DEVELOPMENT APPLICATION ASSESSMENT REPORT

Application Number:	DA2023/0314
Responsible Officer:	Michael French
Land to be developed (Address):	Lot 3 DP 23949, 24 Keldie Street FORESTVILLE NSW 2087
Proposed Development:	Alterations and additions to a dwelling house
Zoning:	Warringah LEP2011 - Land zoned R2 Low Density Residential
Development Permissible:	Yes
Existing Use Rights:	No
Consent Authority:	Northern Beaches Council
Land and Environment Court Action:	No
Owner:	Roy Herbert Mercer Janice Helen Mercer
Applicant:	Janice Helen Mercer
Application Lodged:	29/03/2023
Integrated Development:	No
Designated Development:	No
State Reporting Category:	Residential - Alterations and additions
Notified:	06/04/2023 to 20/04/2023
Advertised:	Not Advertised
Submissions Received:	0
Clause 4.6 Variation:	Nil
Recommendation:	Approval
Estimated Cost of Works:	\$ 377,300.00

Figure 1: Side- South Elevation (depicting envelope non-compliance)

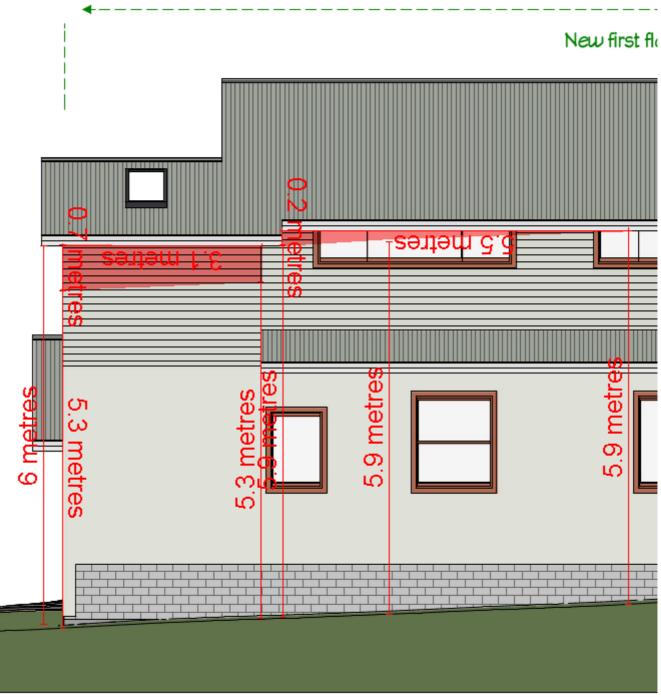
The proposed addition to the dwelling will form two encroachments on the southern elevation:

- 1- Encroachment at a maximum height of 0.7m for a length of 3.1m.
- 2- Encroachment at a maximum height of 0.2m for a length of 5.5m.

The proposed envelope non-compliance is considered minor and will not adversely affect the amenity of adjoining or surrounding sites, or unreasonably detract from the streetscape. Additionally, the proposed works wholly comply with side setback requirements. In this instance a minor variation to *Clause B3 Side Boundary Envelope* is considered to be supportable as the outcomes of the control have been met as outlined below.
